MINERALS PROGRAM INSPECTION REPORT
PHONE: (303) 866-3567

MINE NAME: Rifle Gravel Pit #1	MINE/PROSPECTING ID#: M-2021-052	MINERAL: Gravel and sand	COUNTY: Garfield
INSPECTION TYPE: Surety-Related Inspection	WEATHER: Clear	INSP. DATE: January 28, 2025	INSP. TIME: 09:00
OPERATOR: Western Slope Materials, LLC	OPERATOR REPRESENTATIVE: Sean Mello	TYPE OF OPERATION: 112c - Construction Regular Operation

REASON FOR INSPECTION: Surety Related	BOND CALCULATION TYPE: Complete Bond	BOND AMOUNT: \$0.00
DATE OF COMPLAINT: NA	POST INSP. CONTACTS: None	JOINT INSP. AGENCY: None
INSPECTOR(S): Todd Jesse	INSPECTOR'S SIGNATURE: 	SIGNATURE DATE: February 20, 2025

Photo 1 – View to the east of groundwater monitoring well.

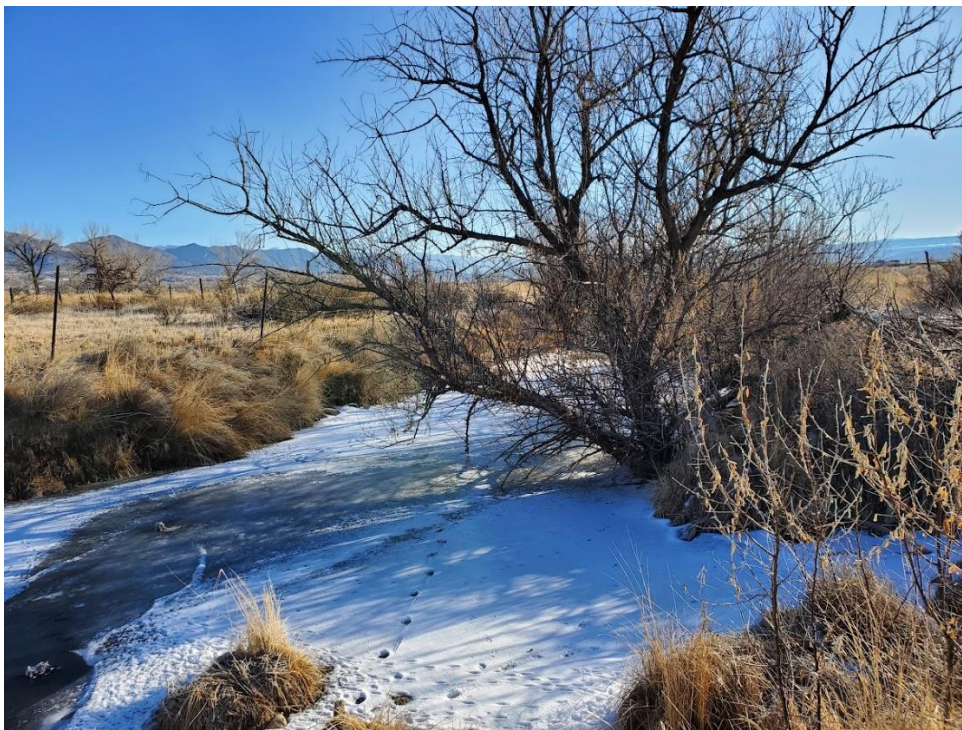
There is no groundwater exposed within the permit boundary. Groundwater monitoring wells were observed in the permit area (Photo 1). There are wetlands within the permit boundary that may be a result of seepage from the Last Chance Ditch Tailwater Ditch. The operator plans on making repairs to the ditch to better define wetlands before mining. The water in the ditch was partially frozen at the time of the inspection (Photo 2).
